FINAL DRAFT MINUTES

September 16, 2021 Standards Committee Meeting

RE: Minutes from the September 16, 2021 Standards Committee Meeting

E 801-TCTC-10 MAINTENANCE OF TRAFFIC FOR RPM REFLECTOR REPLACEMENT (WITH MARKUPS)

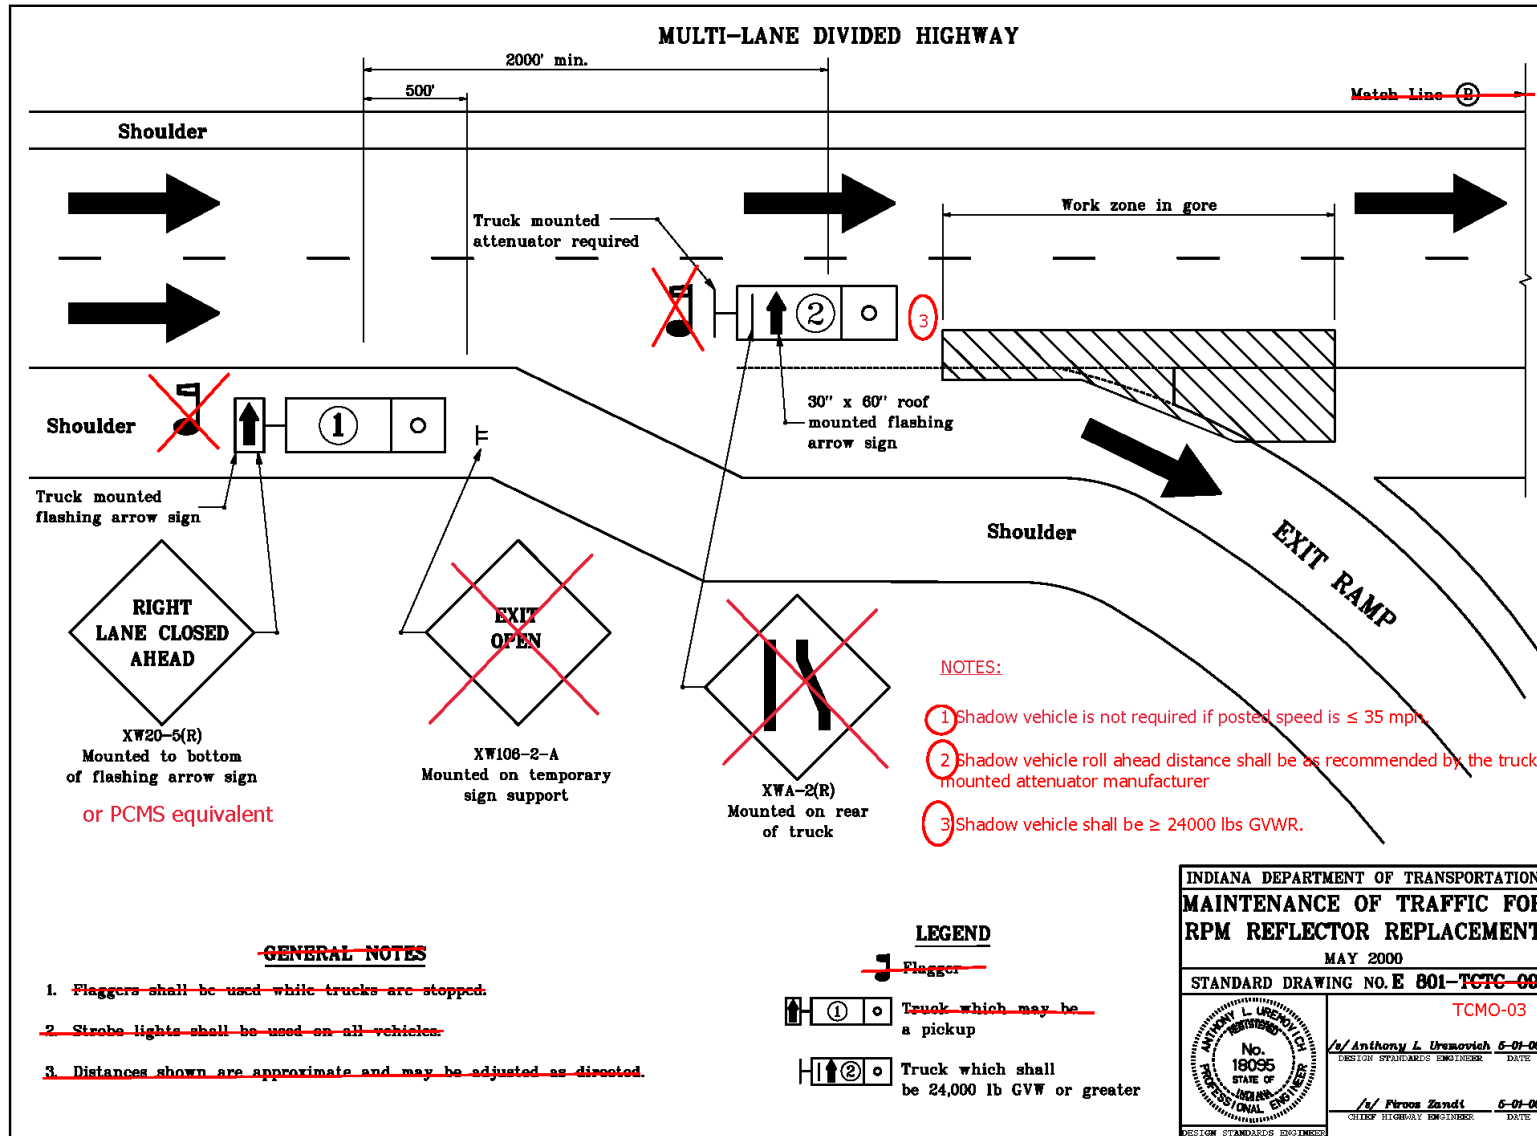
Move to new series on Traffic Control for Mobile Operations
